GPU Nuclear Corporation

May 24, 1996
C301-96-2027

Subject: Saxton Nuclear Experimental Corporation
Operating License No. DPR-4
Docket No. 50-146
Response to the Second Request for Additional Information Regarding
Technical Specification Change Request No. 57 dated May 5, 1996.

The purpose of this letter is to submit the response to the Second Request for Additional Information regarding Technical Specification Change Request No. 57, which addresses the proposed expansion of permissible work scope at the SNEC facility.

FIGURE 1 (Rev. 1)

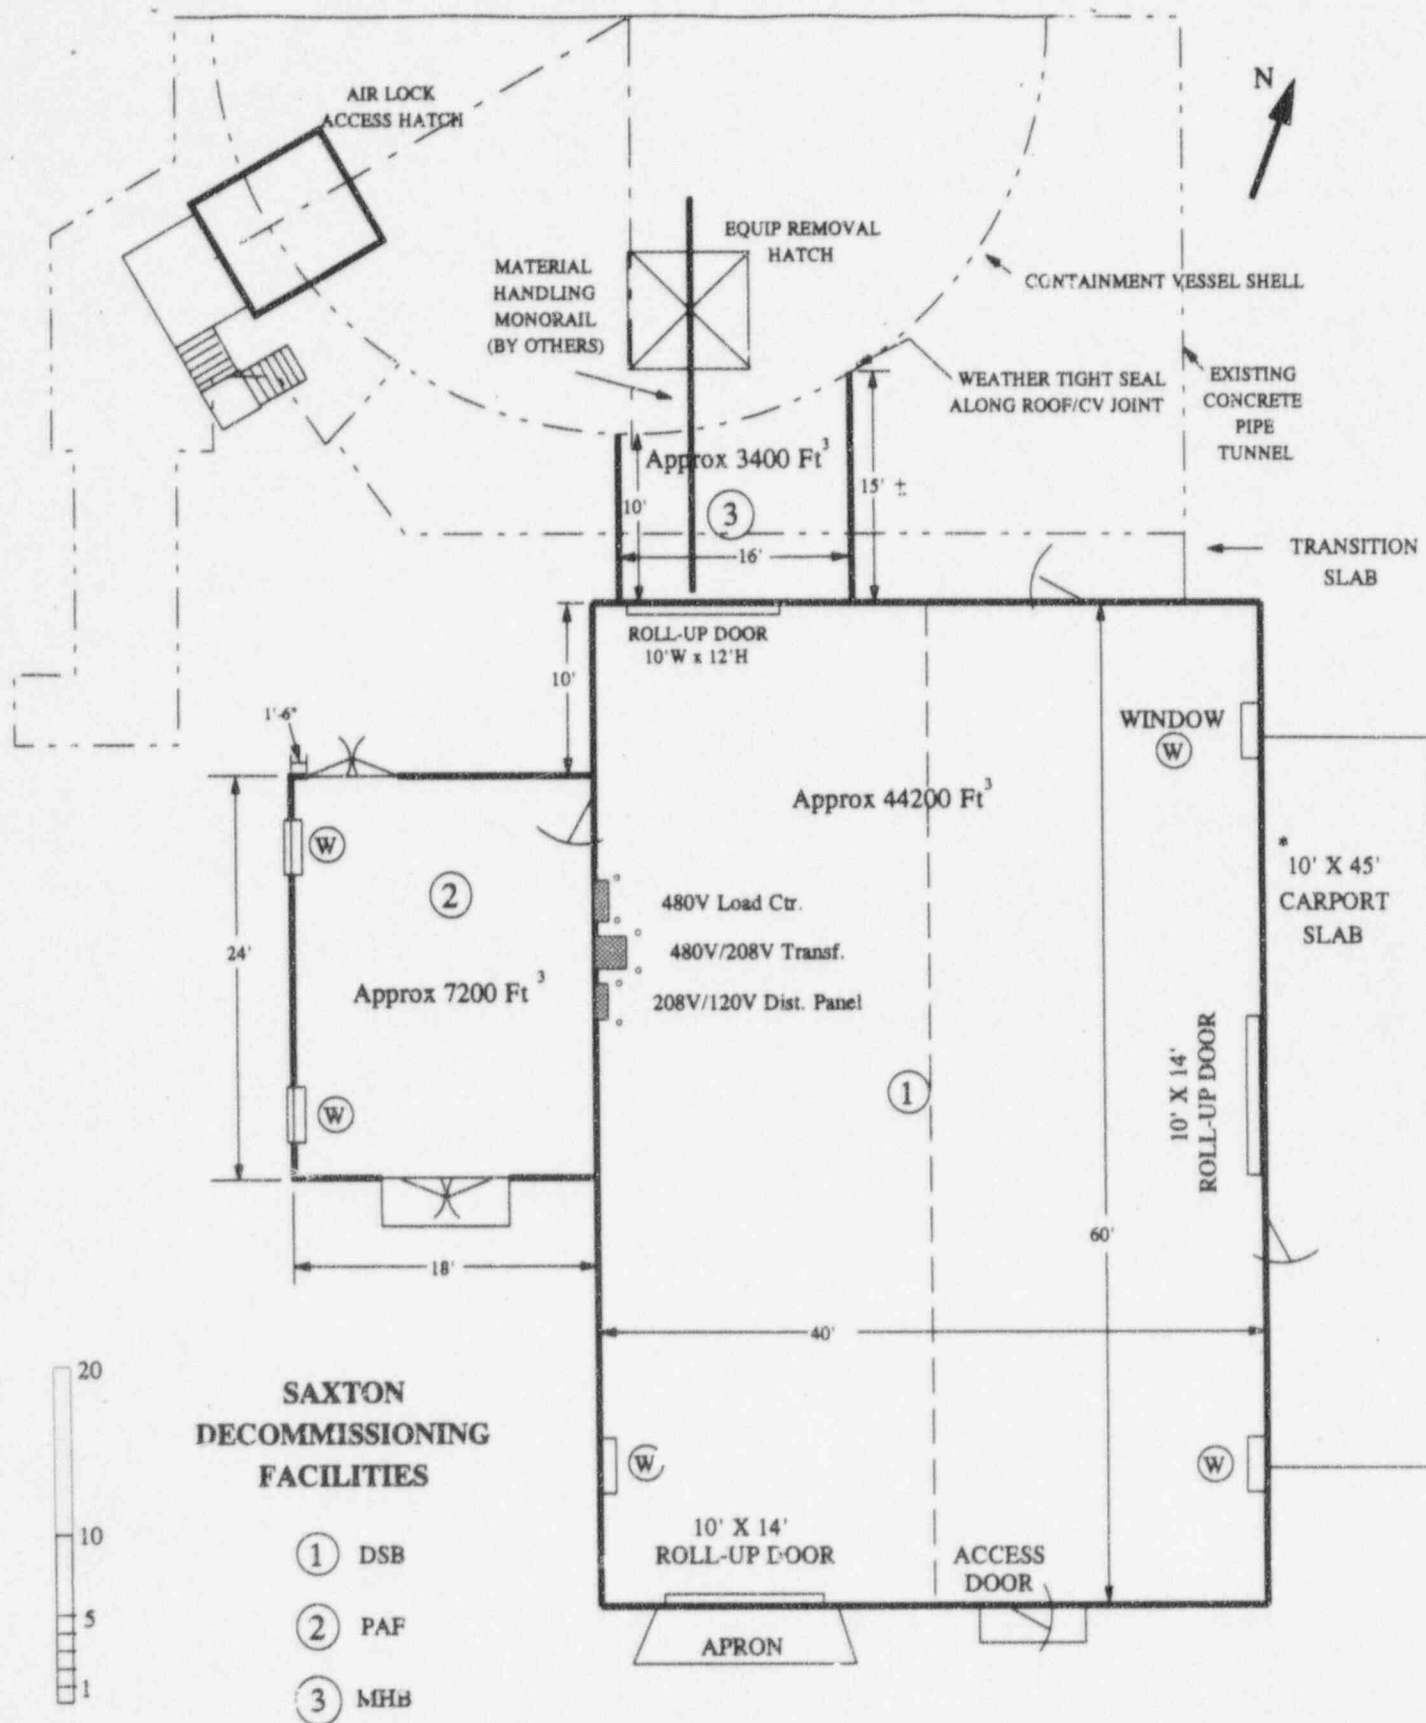
Question 2: What is the size of your proposed decommissioning support facilities?

Response: The decommissioning support facility dimensions are as described below and depicted on Figure 1 (Attachment 2):

- Decommissioning Support building is a 40 by 60 foot, 18 foot high single story structure;
- Personnel Access Facility is a 18 by 24 foot, 16.5 foot high single story structure; and
- Material Handling Bay is 16 feet wide and conforms to the exterior of the CV.
